Access Compliance Report Public Rights-of-Way (Pedestrian Signals)

Intersection ID: N/A	Main Street:	Cross Street: N/A	Location: N/A
ADA ID: 59AF7C4BE84F	Signal Type: Two Push Buttons-Non APS	Overall Compliance: No	Severity Score: BTN 1:N/A BTN 2: N/A No BTN: N/A
Codes/Mitigation Info/Possible Solution		Field Measurements/Component Compliance

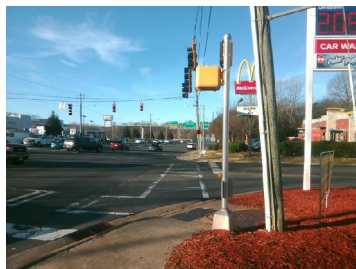
PROW/ADA: TMUTCD 4e.08, R404.3, R404.2, R406.2

Yes	B 1 Clear Xing Direction?	ClearlyMarked	Yes	B 2 Clear Xing Direction?	ClearlyMarked
	B 1 Crossing Direction	To SW		B 2 Crossing Direction	To SE
Yes	B 1 DistanceTo XWalk (in)	0.0	Yes	B 2 DistanceTo XWalk (in)	55.0
No	B 1 DistanceTo Curb (in)	74.0	No	B 2 DistanceTo Curb (in)	74.0
Yes	B 1 Diameter (in)	2.0	Yes	B 2 Diameter (in)	2.0

Possible Solutions: Replace Signal Push Button With APS Button on New Post. Remove & Relocate Sign.
